W0-A-0049

BADAKSHAN BRIDGE #12

FINAL INVESTIGATION REPORT

KESHIM-FAIZABAD ROAD, BADAKSHAN PROVINCE

Hydraulic Inspection of Bridge

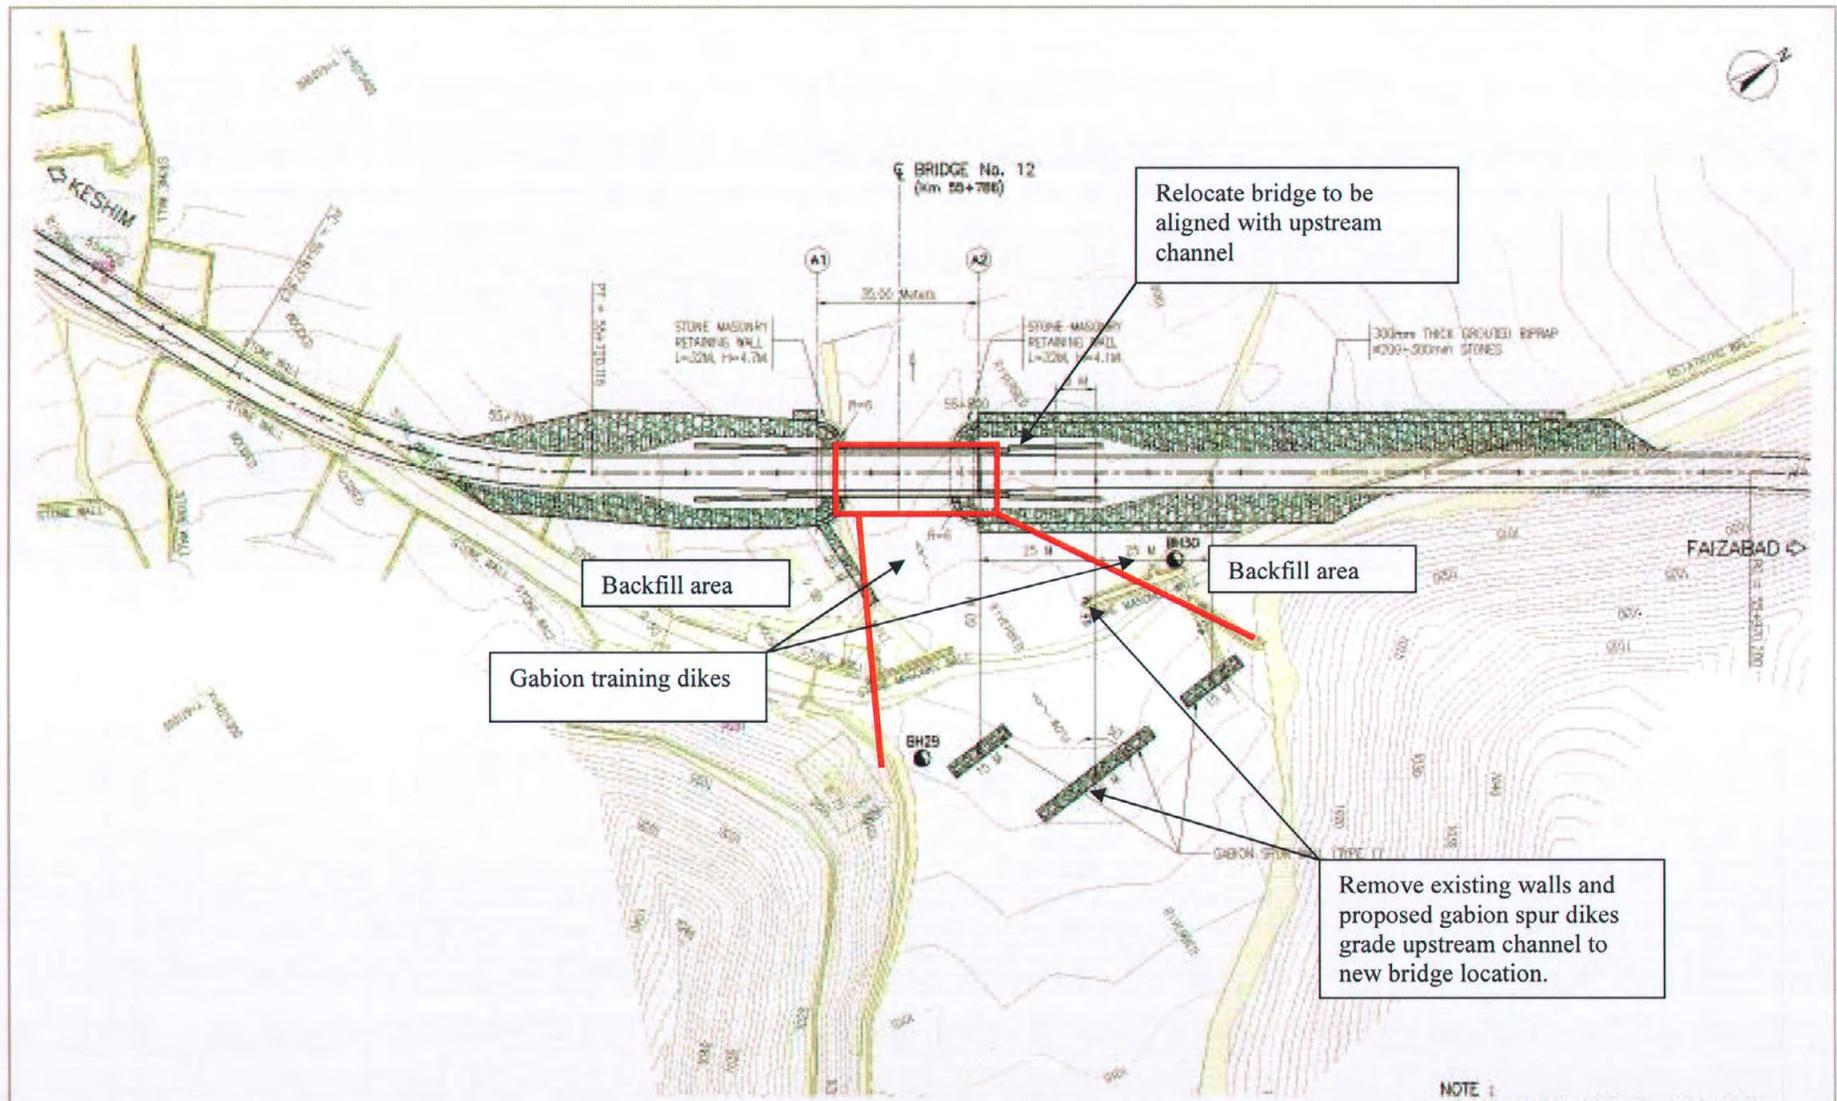
Type: Masonry wall structures Size/Span: 30 meter low flow
Height: n/a Condition: Fair condition
Wingwall condition: good Evidence of ponding: none
Scour upstream: n/a downstream: n/a
Evidence of Debris: none Sediment: none
Erosion Control Measures: none
Scour potential at proposed abutment: potential for scour at proposed abutments
Scour potential at proposed pier: n/a "clear span"
Remarks : Proposed structure: 1 span 35 meter bridge. Proposed bridge does not appear to be aligned with direction of flow.

Recommendations: Remove gabion spur walls upstream of bridge as located they will train flow to north abutment. Training dikes or embankment should be extended to existing stone masonry walls. Abutments should be designed to resist designed scour depths. Move bridge north 5 meters and regrade existing channel to train flow into bridge.

1 ABUTMENT FOUNDATION PLAN
SCALE 1:100 M

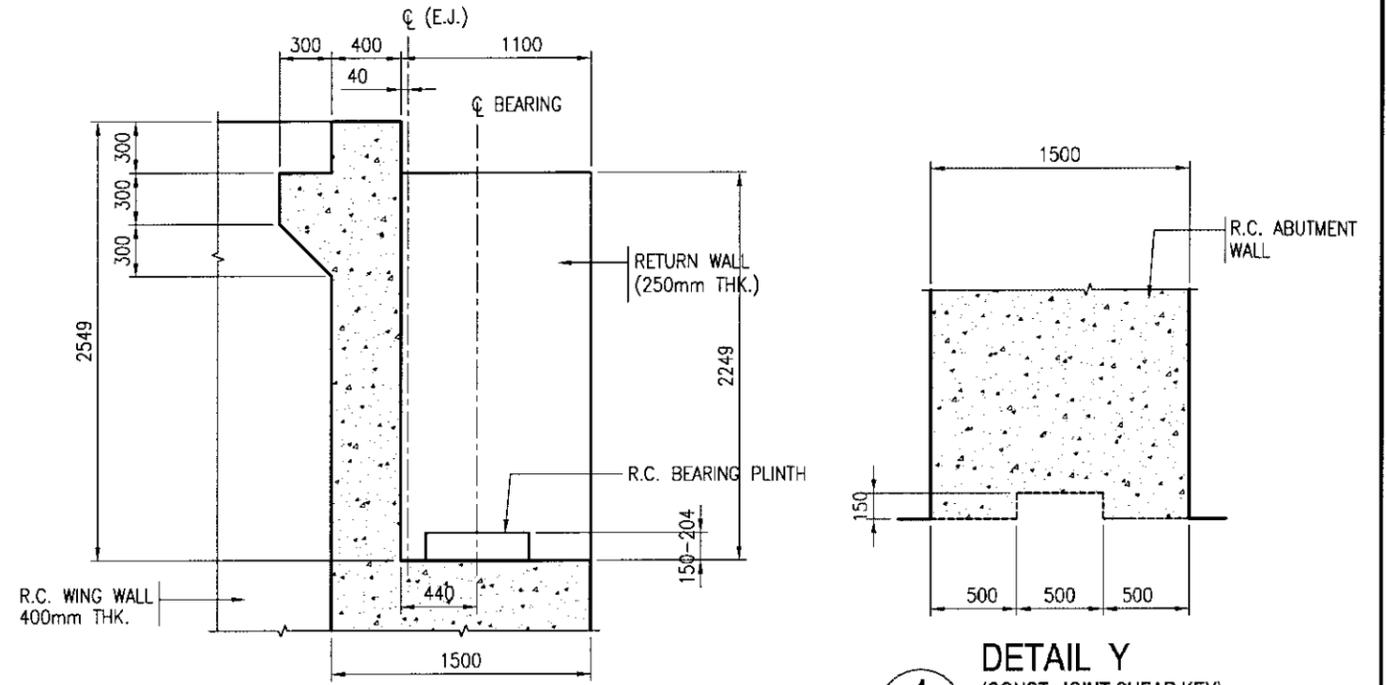
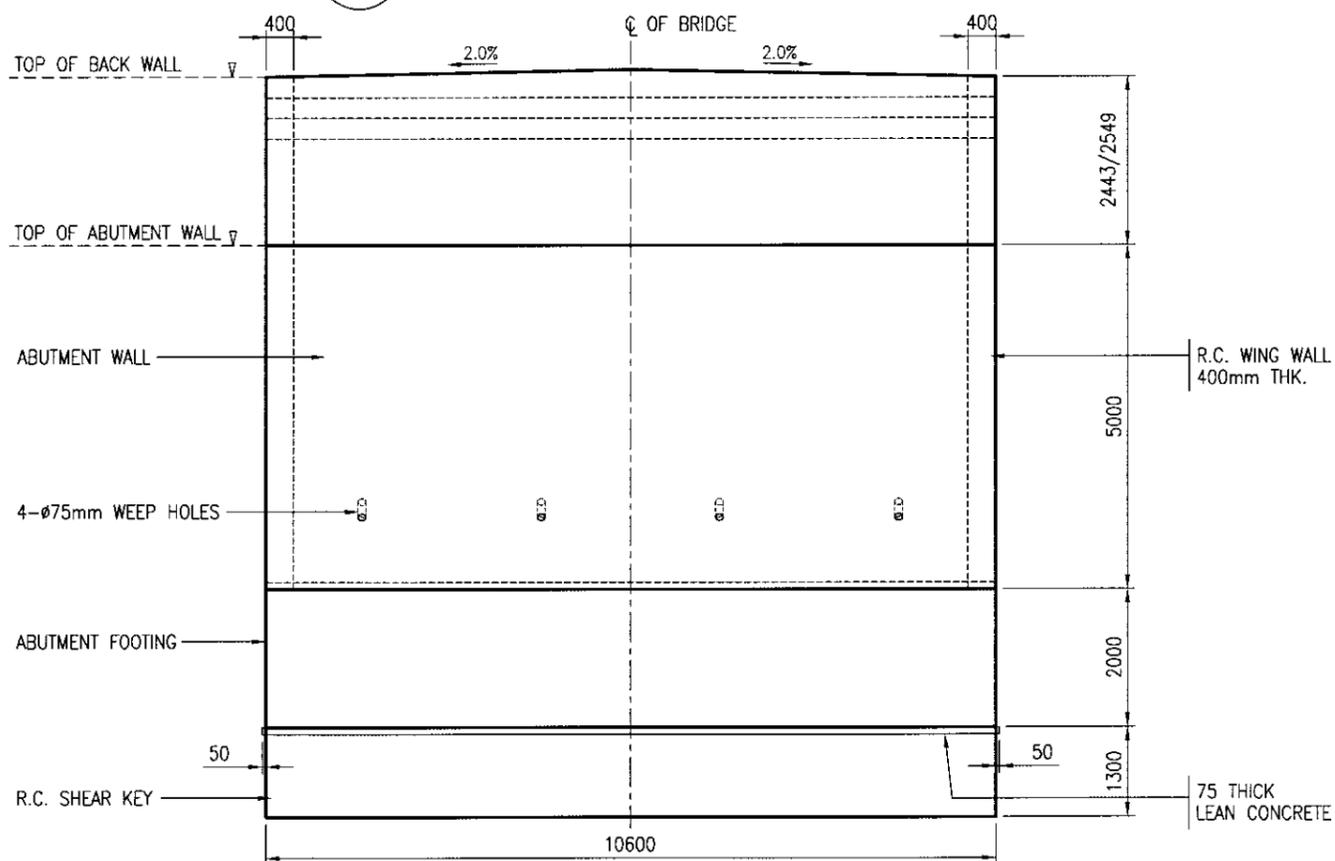
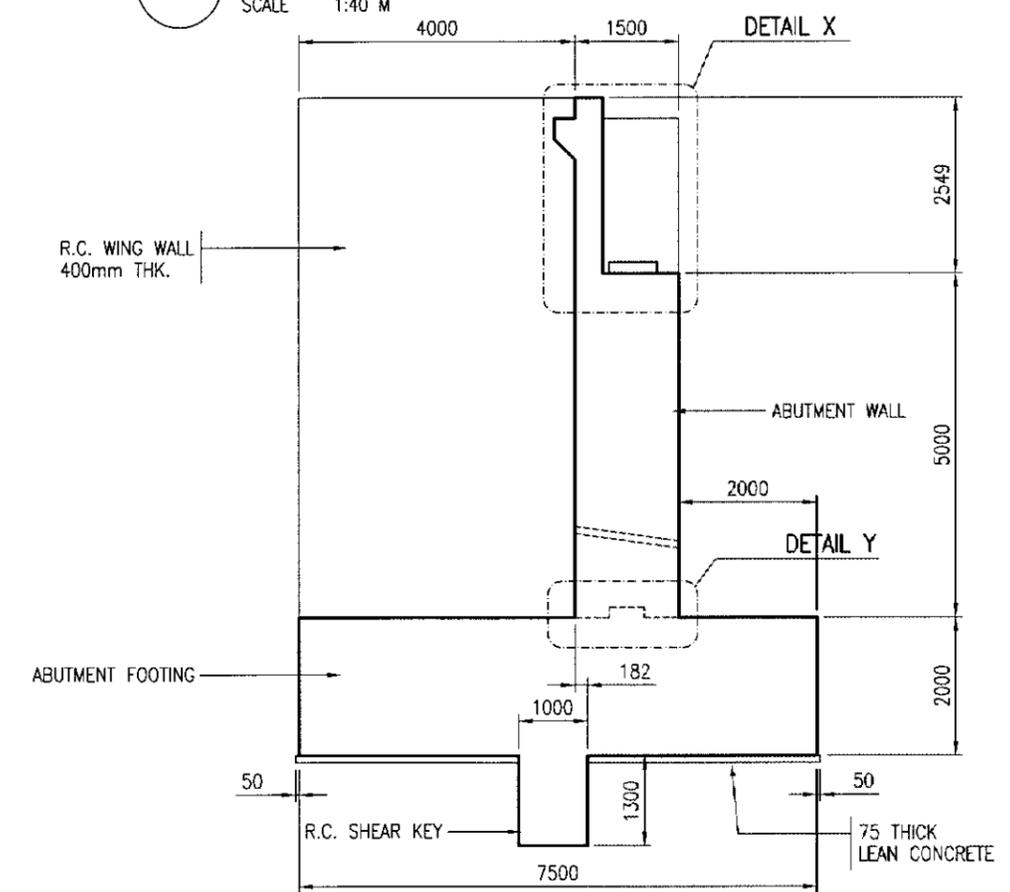
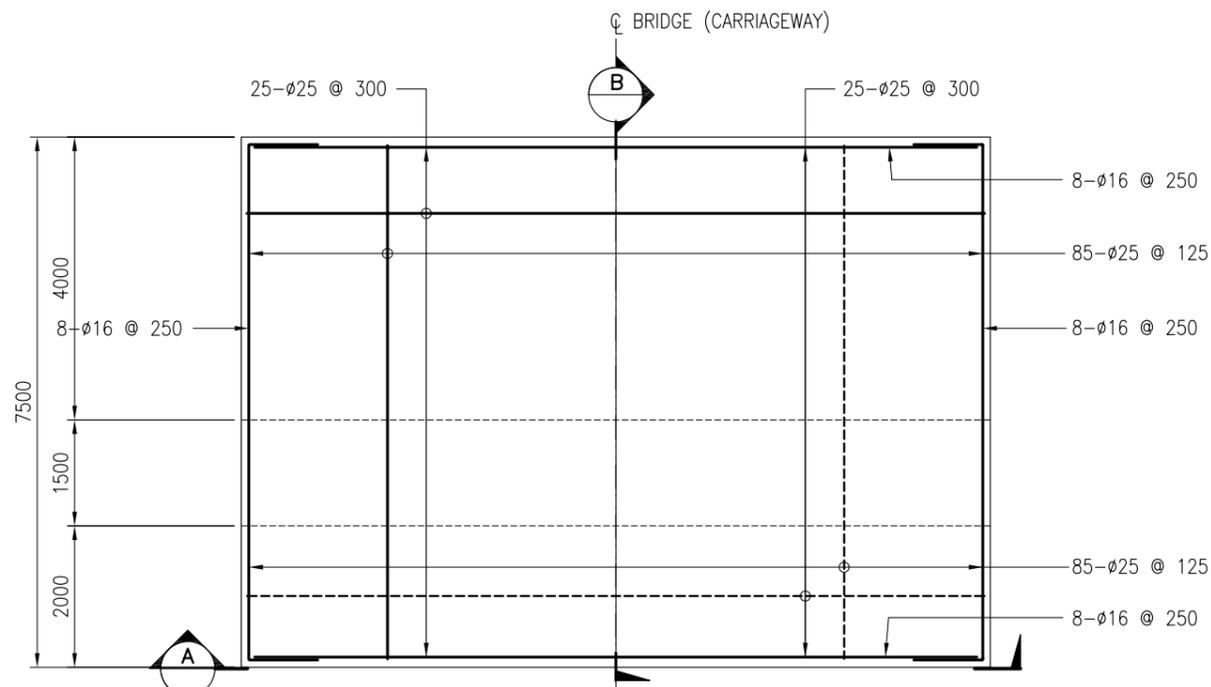
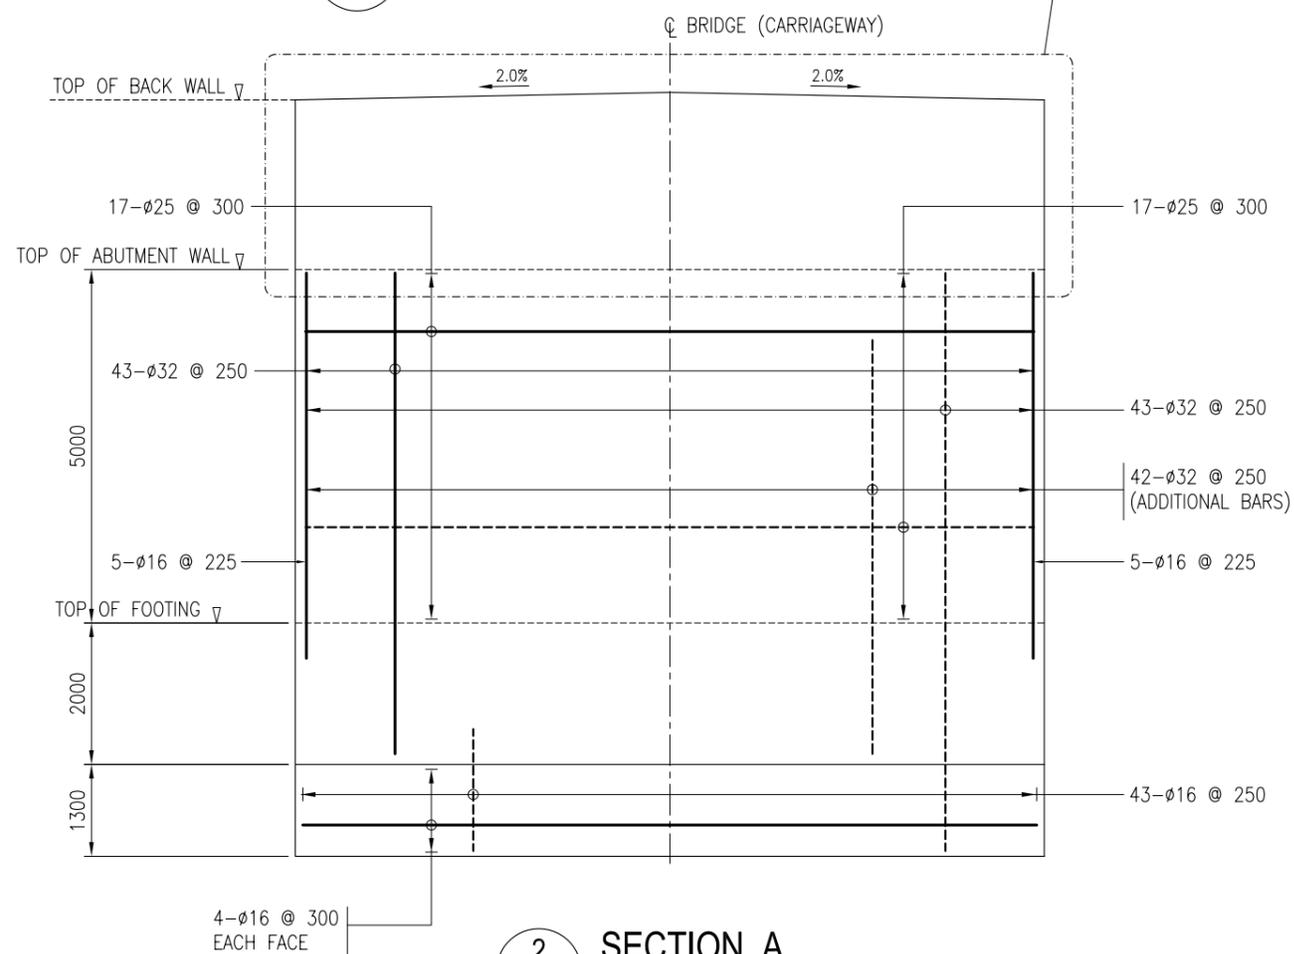
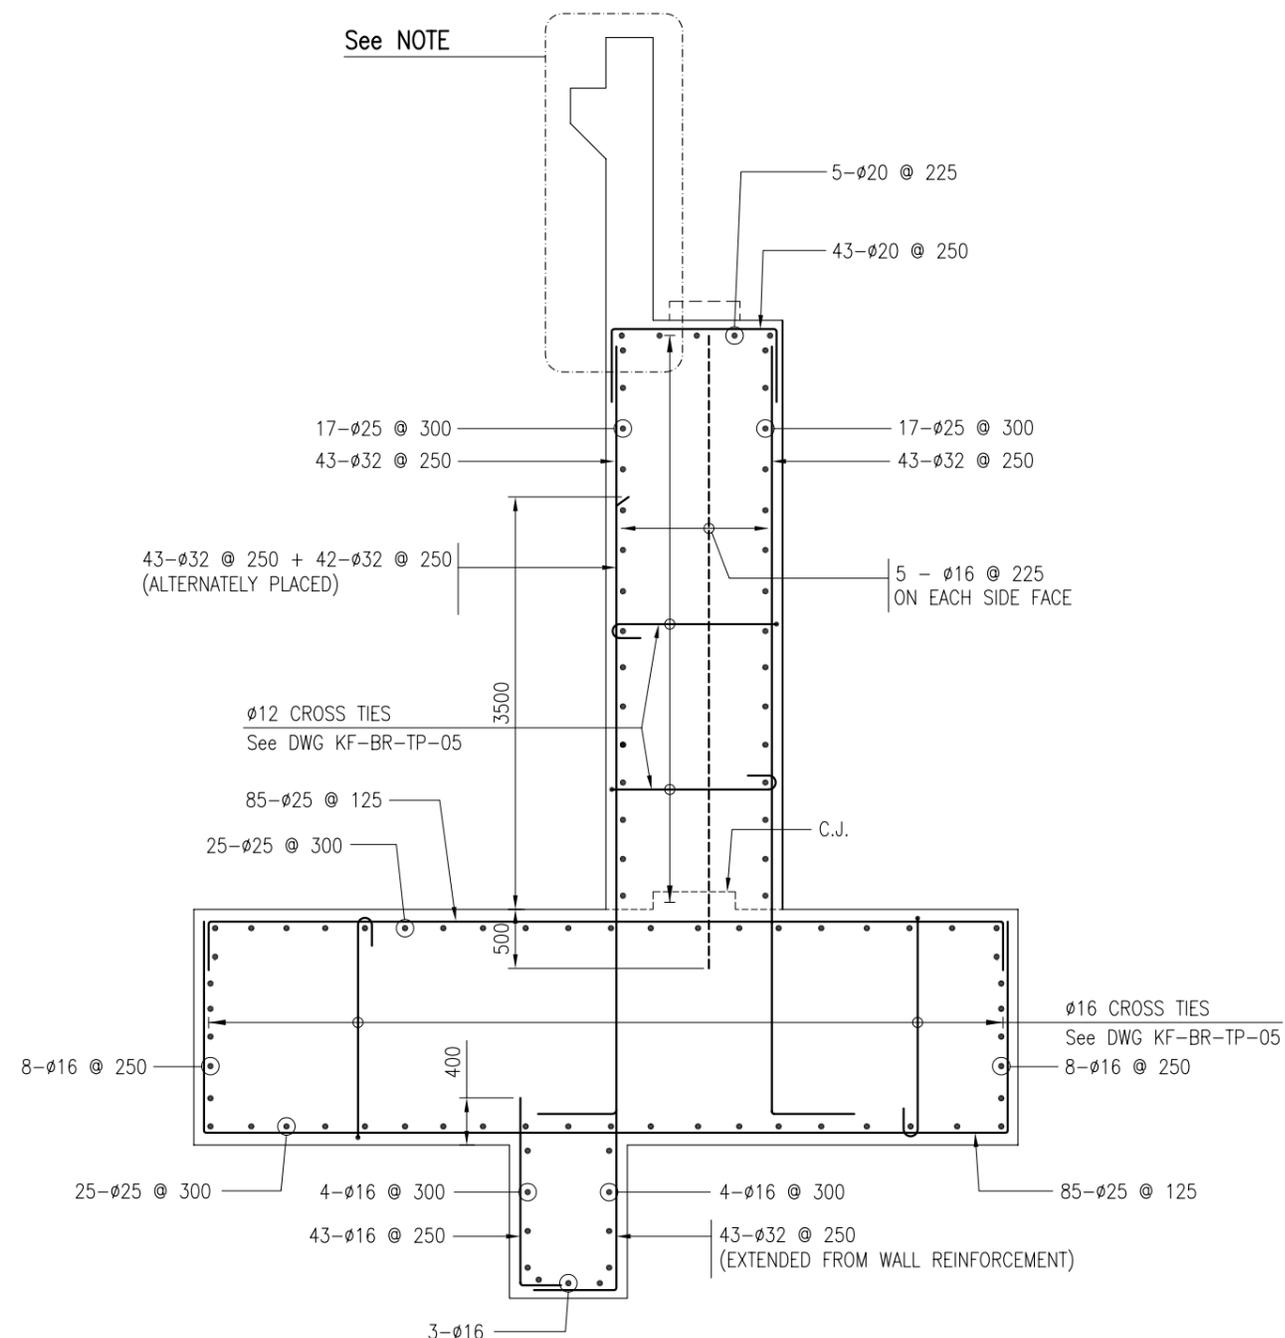
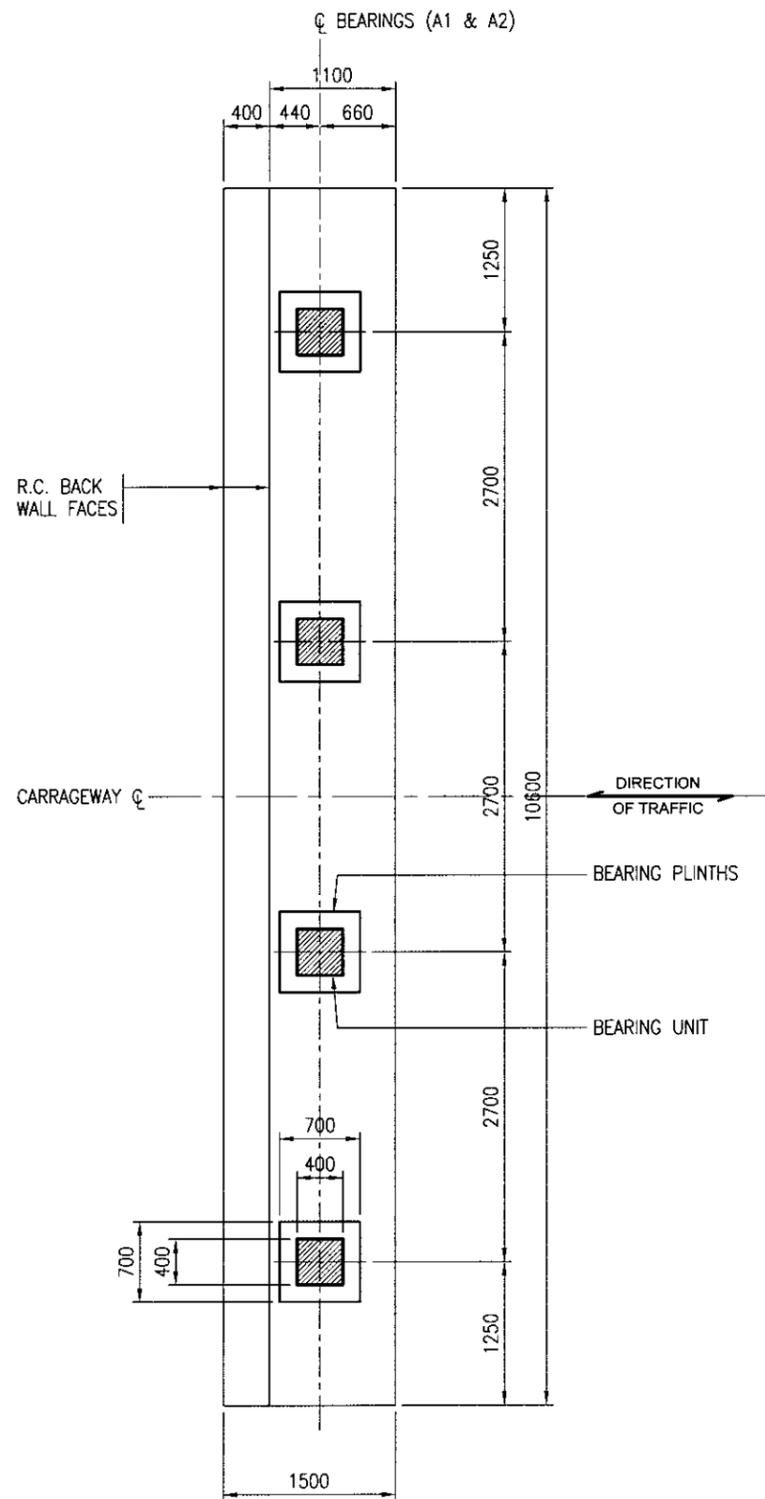
- Information was not provided that indicates specific attachment or restraint of the bridge bearings to the abutment bearing seat, nor do the reinforcing details indicate the presence of reinforcement in the abutment 250mm return walls.

- The Bridge 12 plans provided to Tetra Tech do not appear to be the plans that were used for the construction based on the photos. The abutments were built with counterfort abutment walls for support which are a significant deviation from the plans provided.
